MEMORANDUM

SUBJECT: Site Plan Approval – 1851 State Street

DATE: December 1, 2022

Request: Site Plan Approval for the construction of an 864 square-foot (SF) building to house two (2) drive-thru Interactive Teller Machines (ITM), an interior asphalt loop, and related site improvements at 1851 State Street, Parcel Number 5-21-122.200

L-100

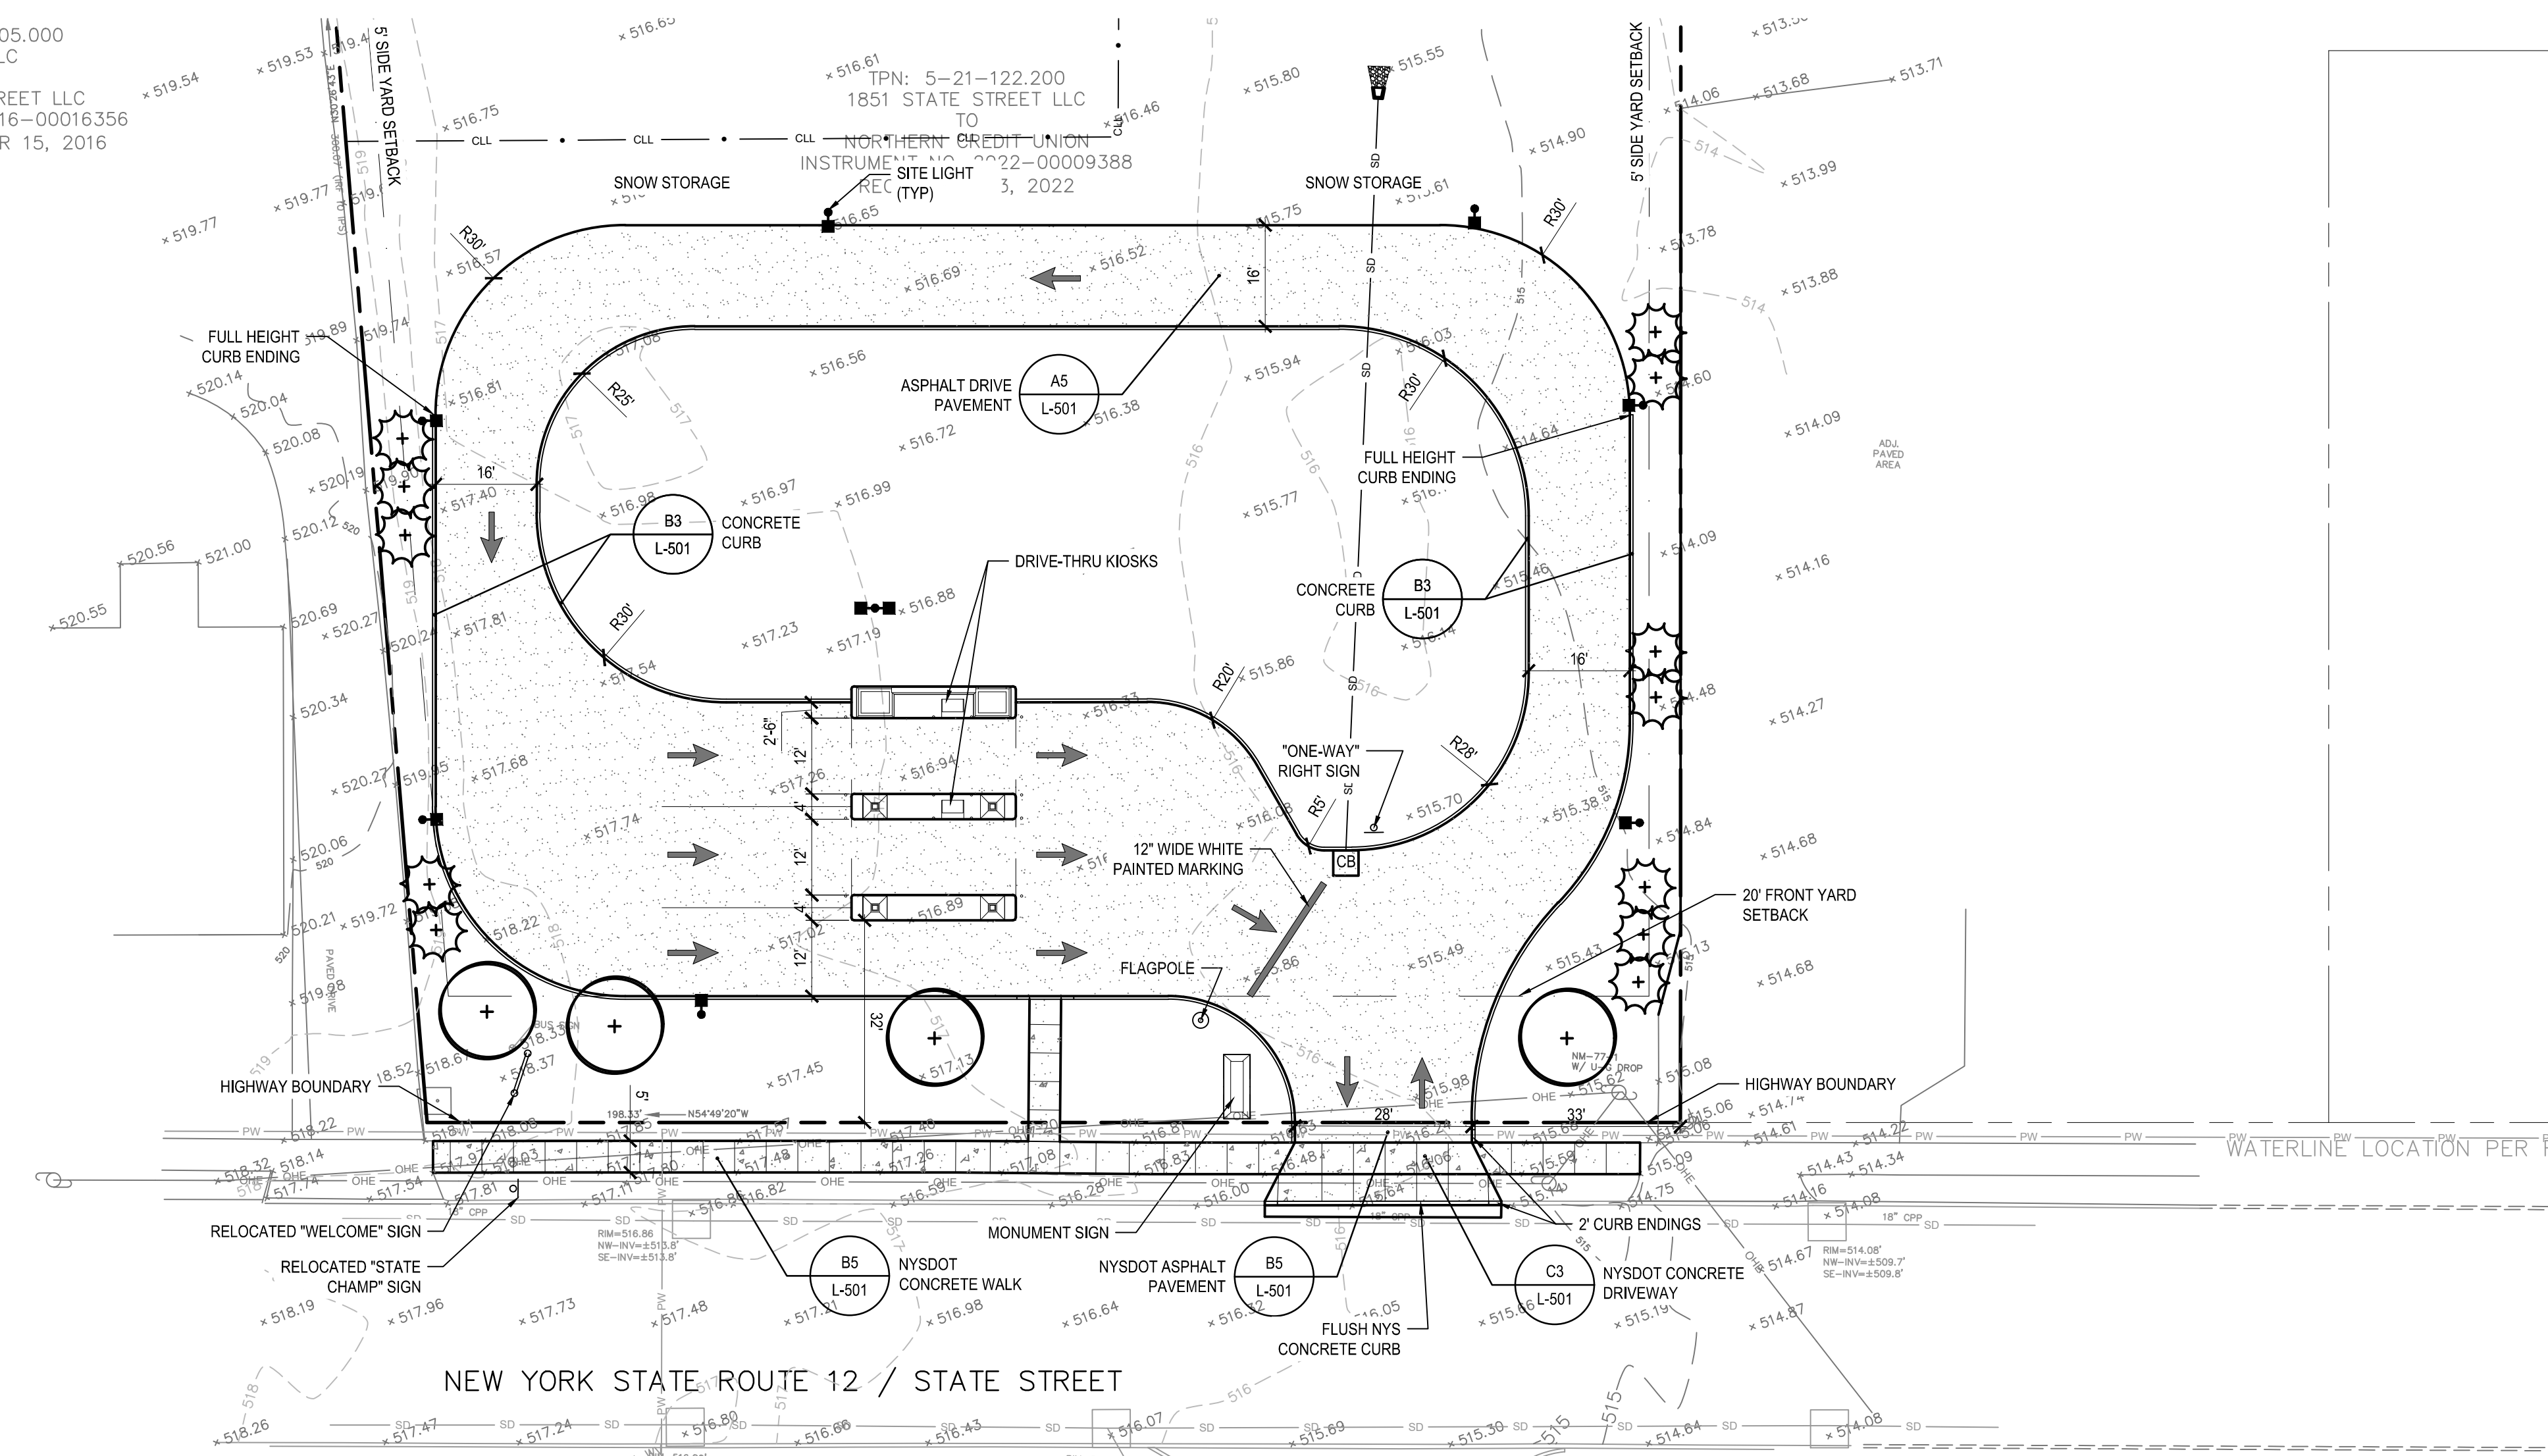
The photometric plan also depicts a light that appears to be mounted to the rear (north) side wall of the proposed structure. The L-100 Site Plan drawing depicts a light pole on the center island to the north of the structure. The applicant shall clarify this discrepancy and confirm which location is accurate.

1. The applicant shall address the lighting discrepancy between Sheets L-100 and LC-100 and confirm the location and style of proposed lighting on the center island.
2. The applicant must obtain, minimally, the following permits prior to construction: Building Permit, Sidewalk Permit, Curb Cut Permit, Sign Permit, NYSDOT Highway Work Permit and a Zoning Compliance Certificate.

LC-100

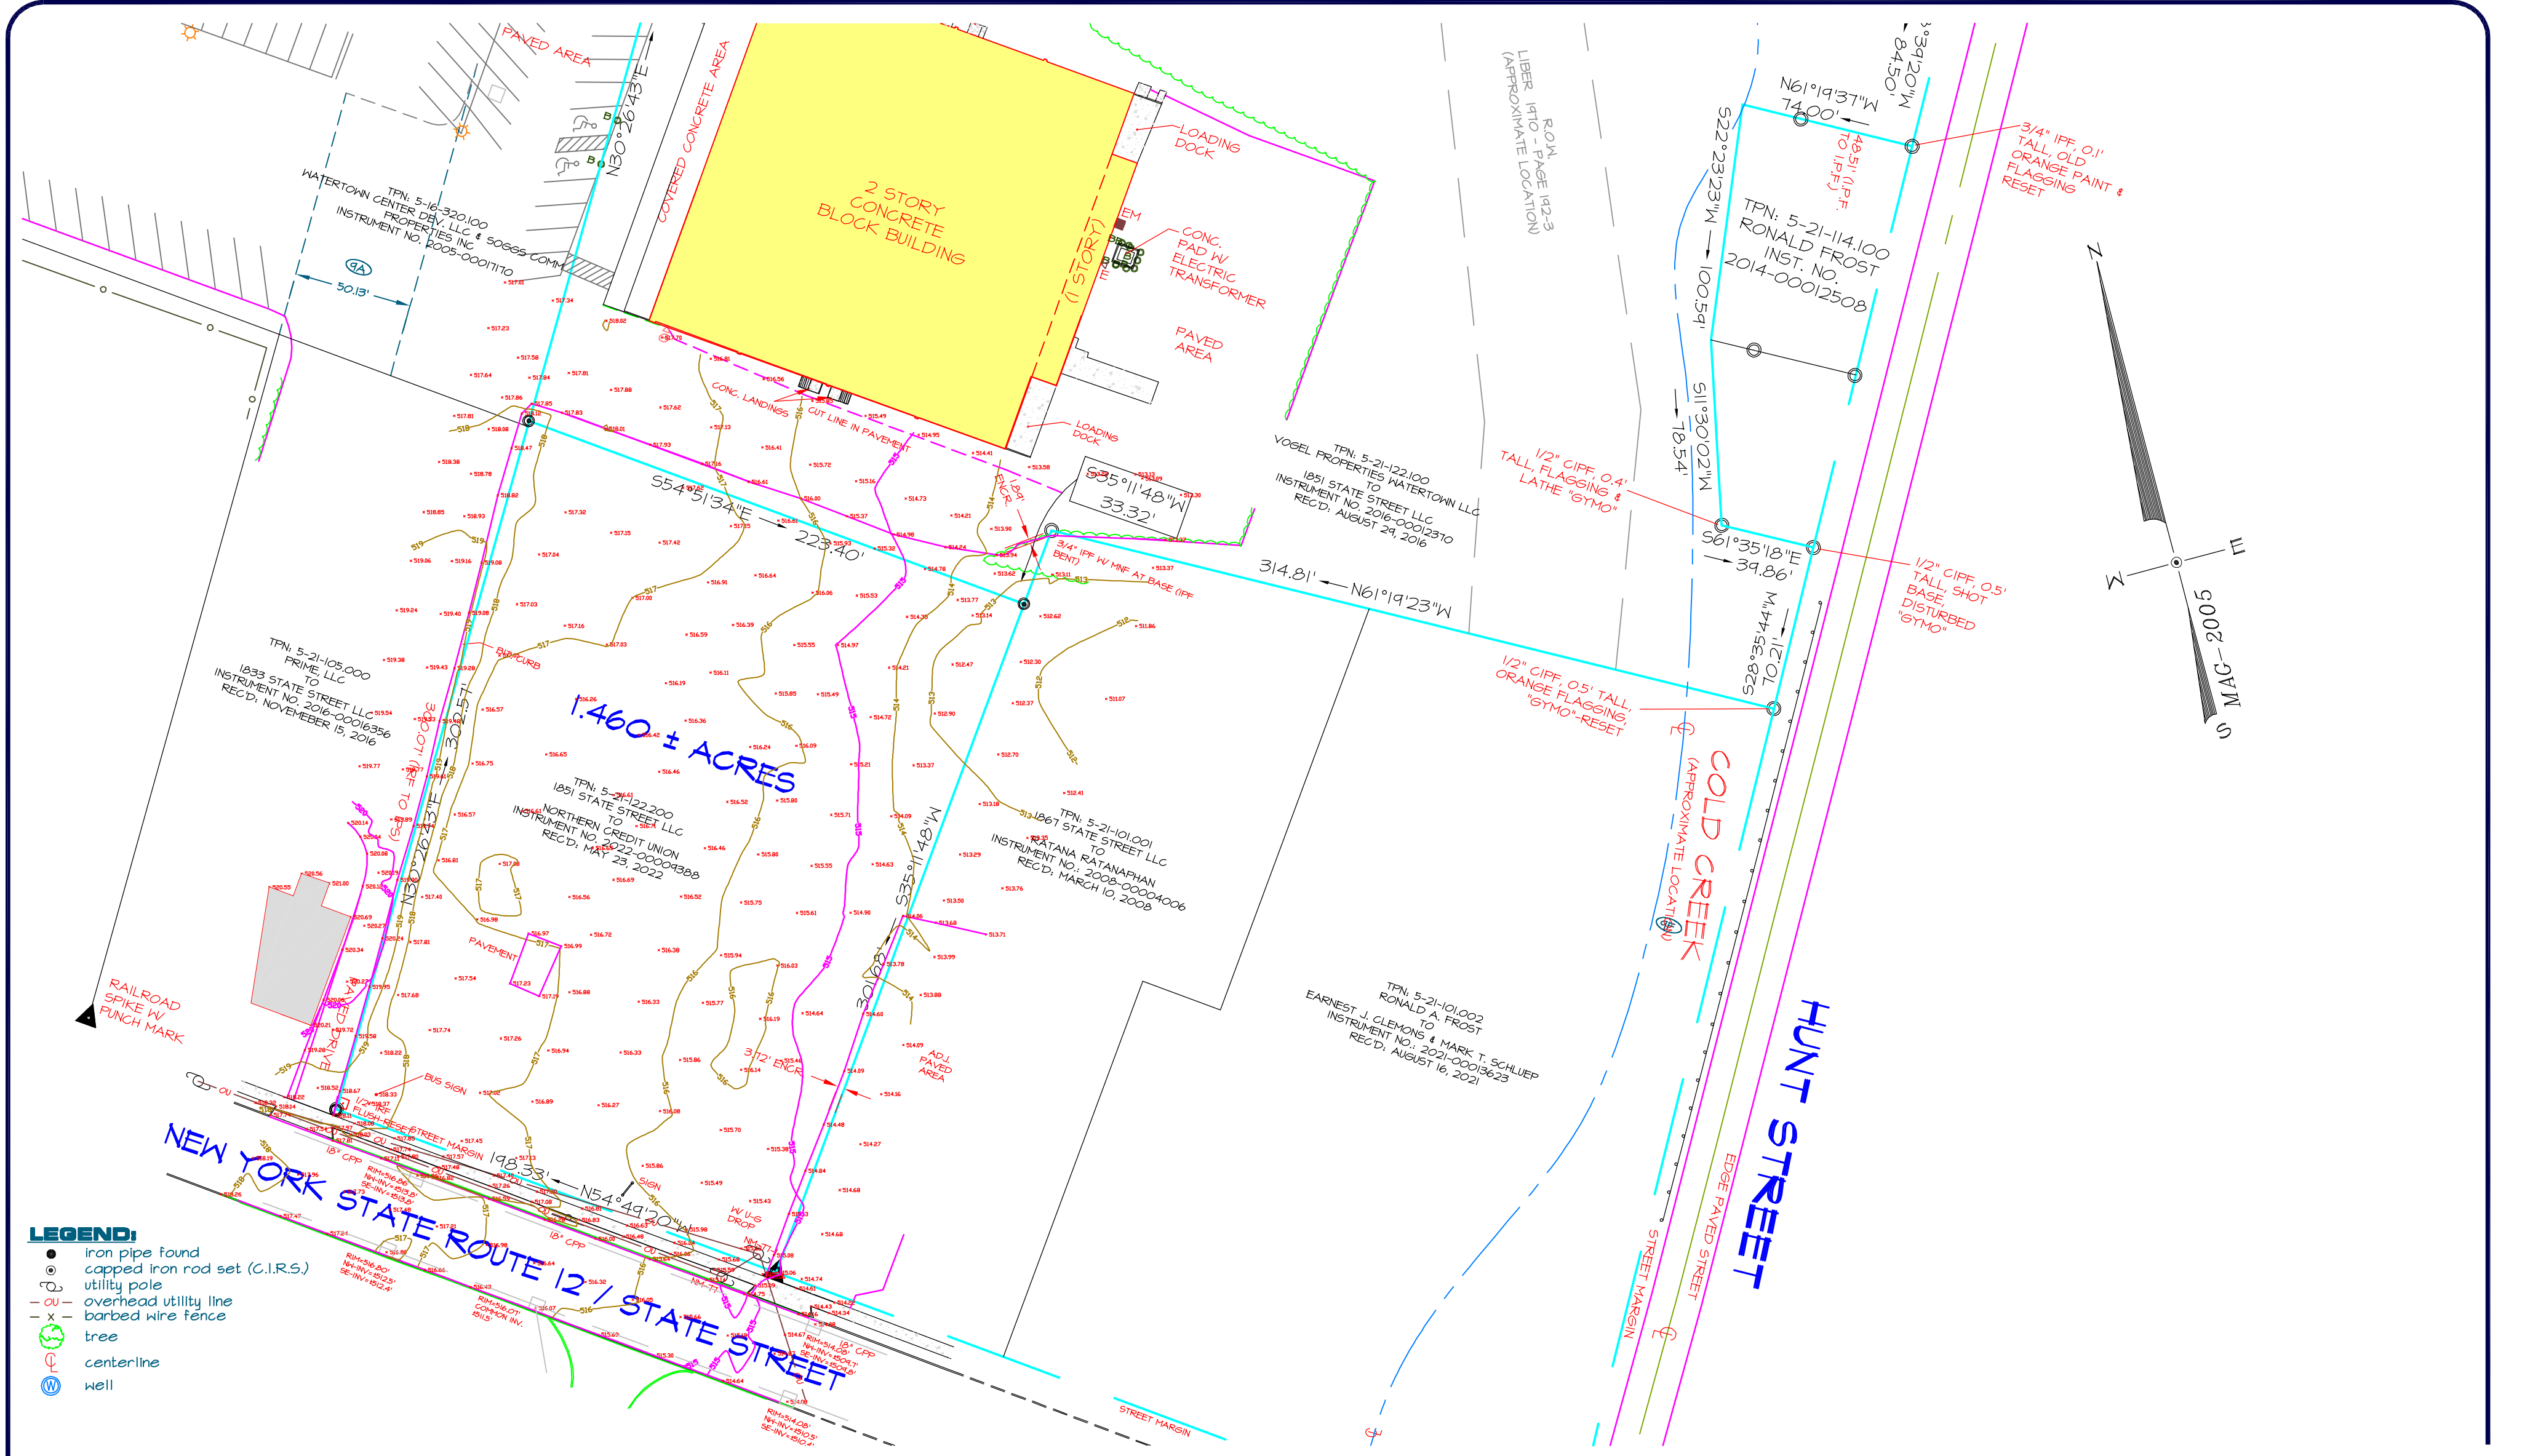
Lighting: The applicant submitted a photometric plan that proposes eight light poles around the perimeter of the drive aisle and four lights that are in (or affixed to) the ceiling of the kiosk canopy. None of these lights will cause excessive spillage over any property lines.
